Staff Report to the Western Weber Planning Commission

Application Request:	Consideration and action on a request for final approval of Winston Park Cluster Subdivision.
Type of Decision:	Administrative
Agenda Date:	Tuesday, June 13, 2017
Applicant:	Jaymak Ogden, LLC
File Number:	LVW040717

The applicant has submitted a request for final approval of the Winston Park Cluster Subdivision, a cluster subdivision consisting of 54 building lots, 17 open space parcels, and 3 common areas. The Winston Park Cluster Subdivision is separated into 2 phases on one subdivision plat, both of which are being presented for final approval as part of the same application. The proposed subdivision is located at approximately 3701 West 1800 South, Ogden, UT and is in the A-1 zone. Public roads will be created with this proposal to provide access to each lot and the design will create connectivity to the surrounding area for future development.

UTILITY PLAN

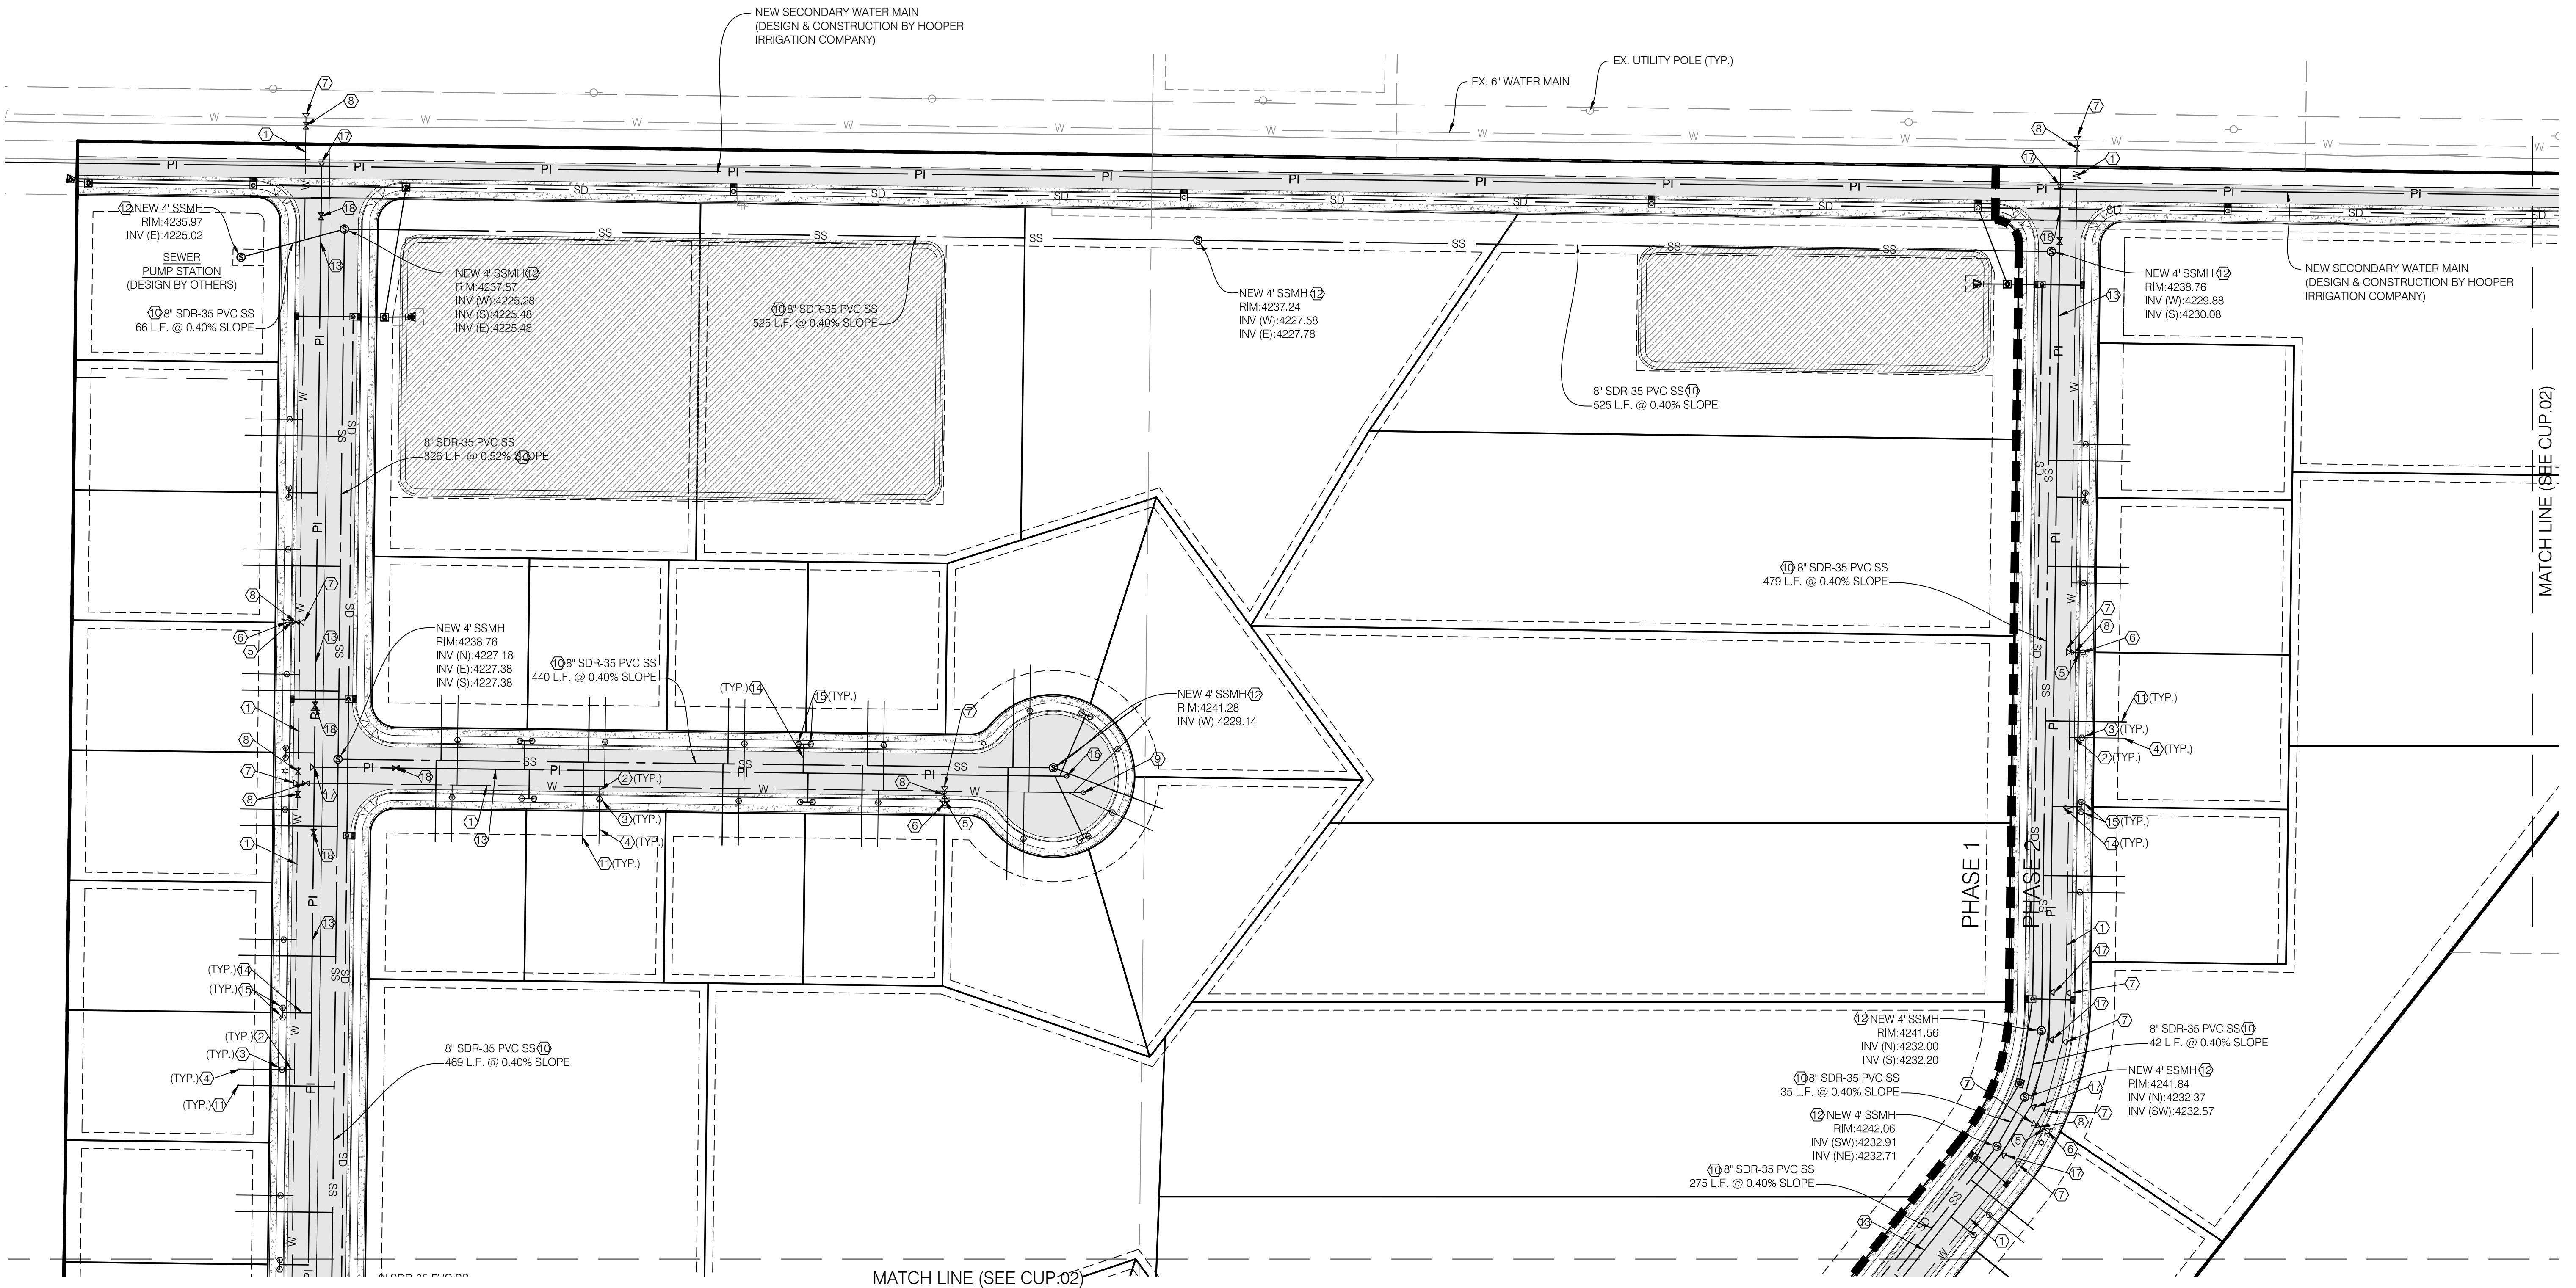
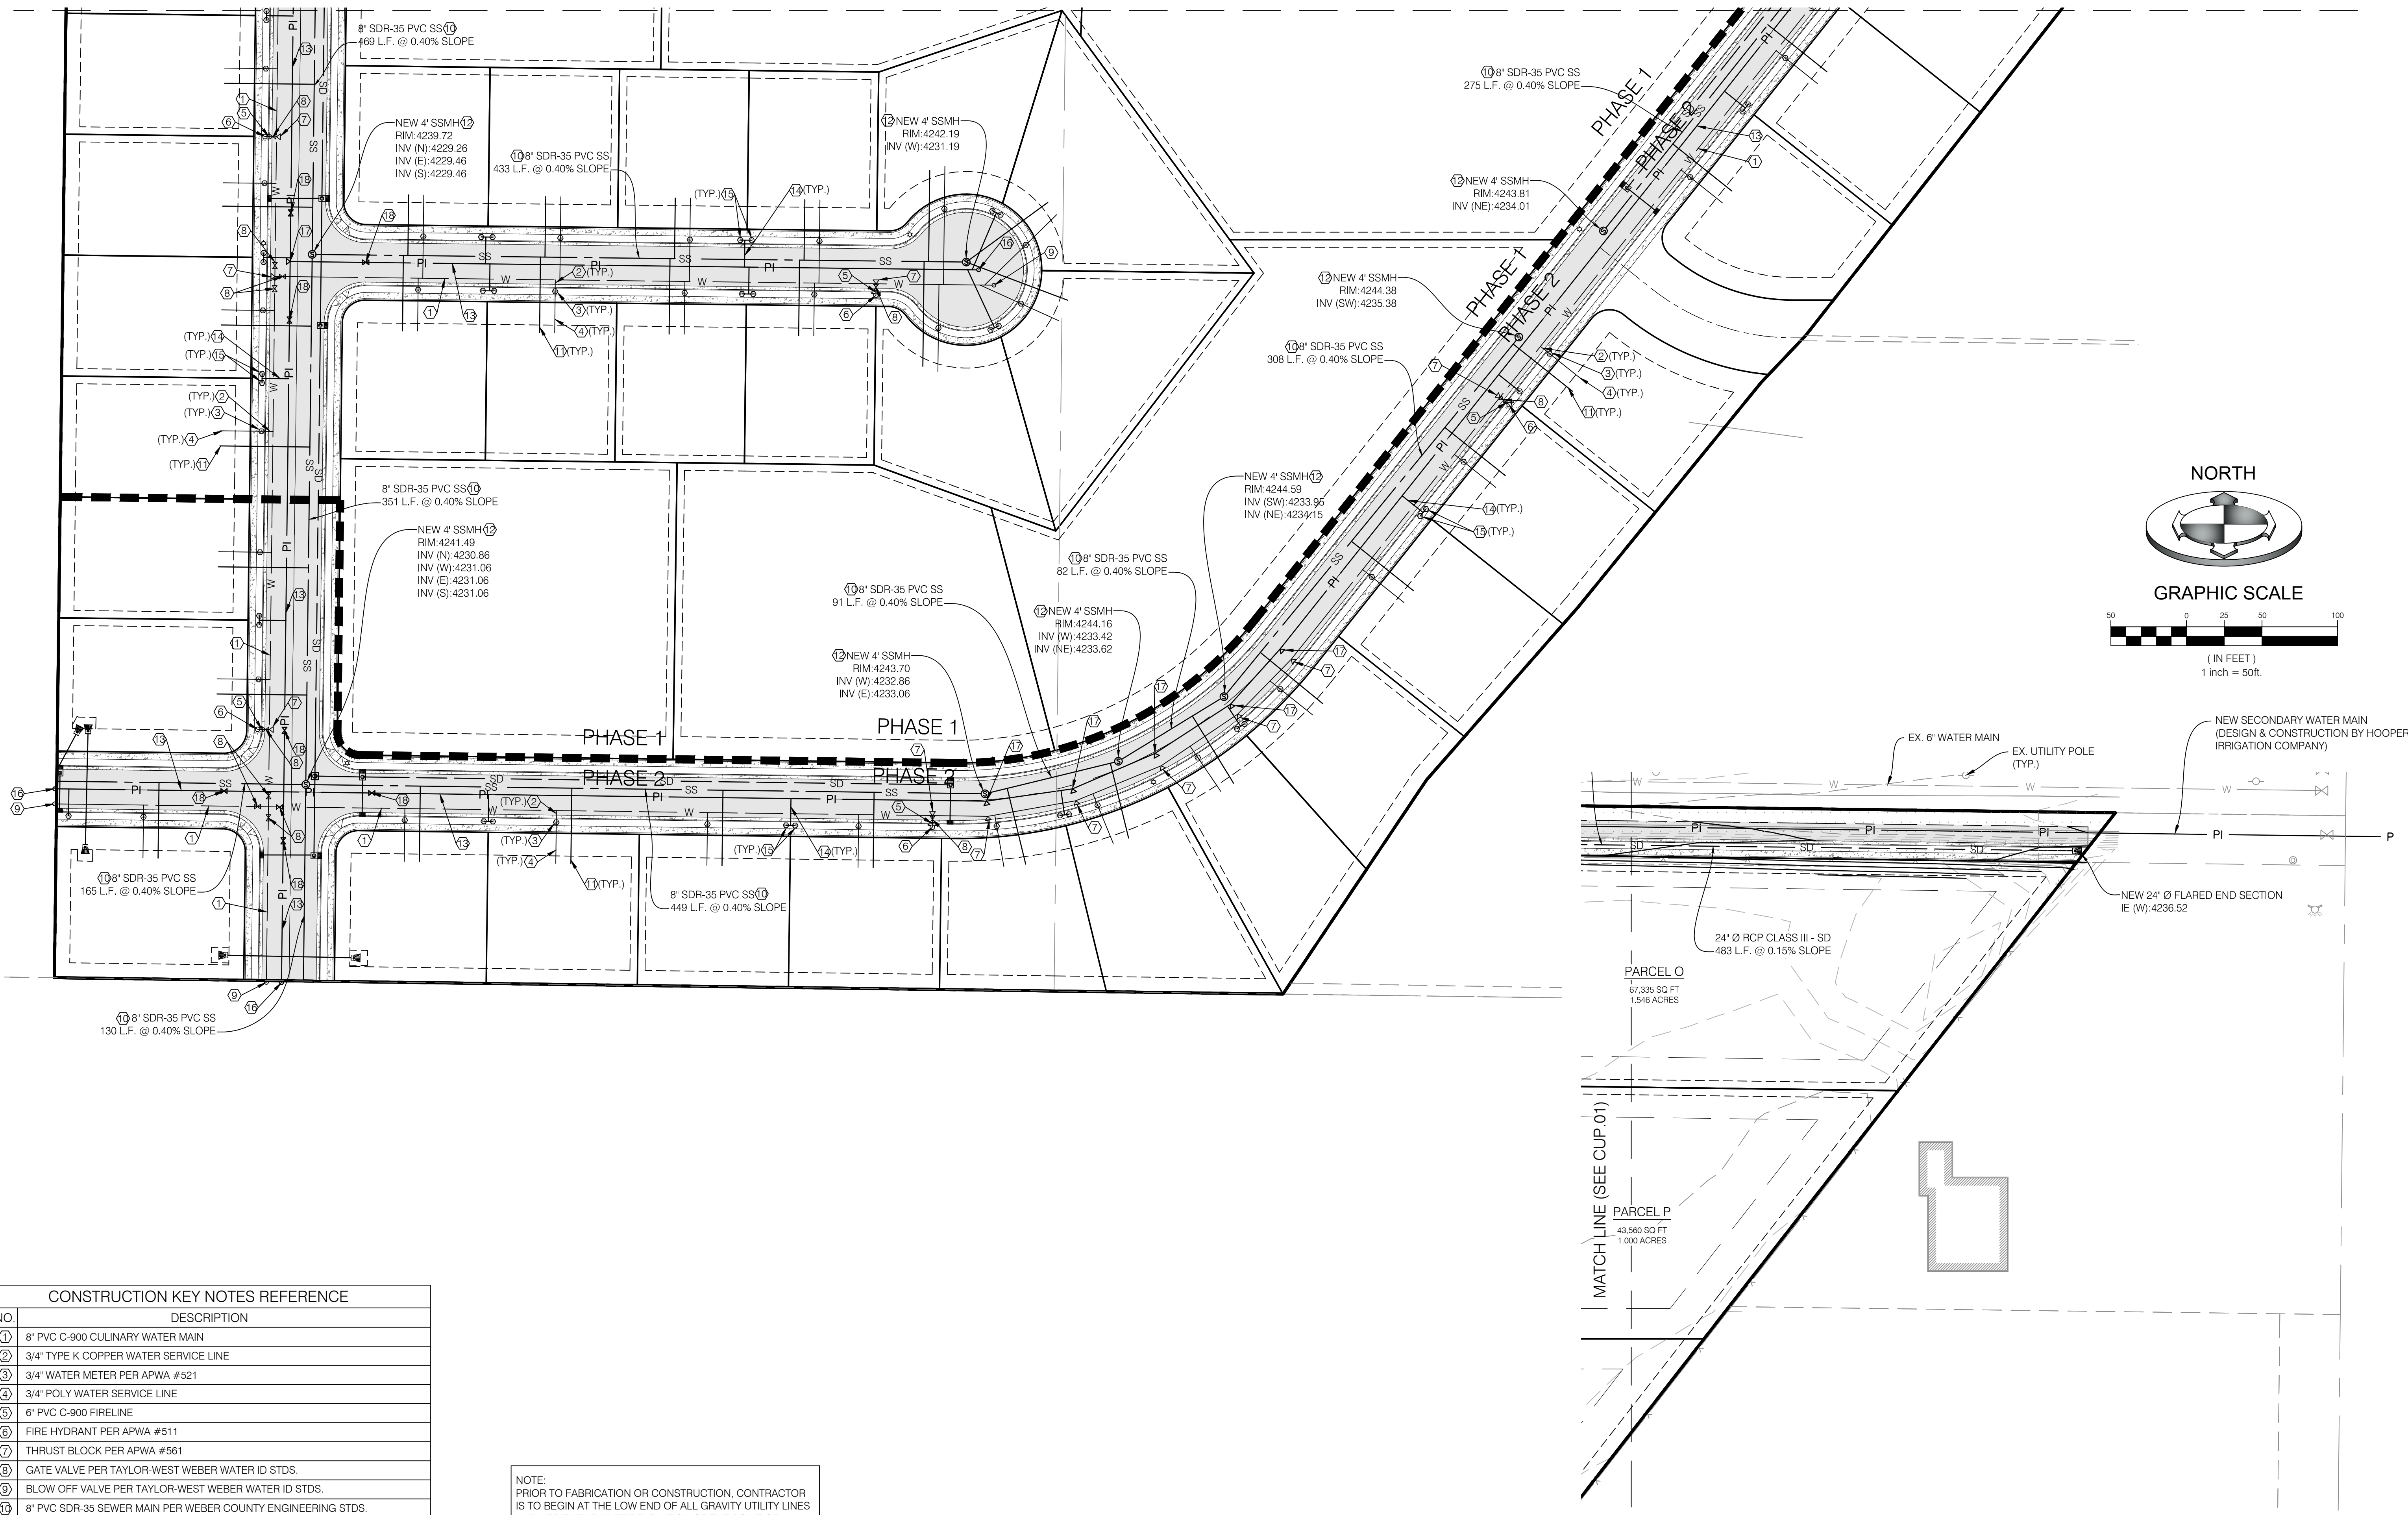
1. The District does not have a gravity flow sanitary sewer line at this location. The closest lines to serve this area are either at the intersection of 1800 South 4300 West or due south of the proposed subdivision on 2200 South. The preliminary utility plans show a sanitary sewer pump station to be constructed in the northwest corner of the subdivision. The connection point from the discharge of the pump station to the District's line is not shown.

3. The District will need to review the location and engineered detail of the point of connection to the District's sanitary sewer lines.
4. The utility drawings indicate a sanitary sewer line being constructed through Agricultural Lots A through E. While the District will not own or maintain these lines we feel there should be a dedicated easement provided to either the County or an entity that will have ownership responsibility for this sewer line.
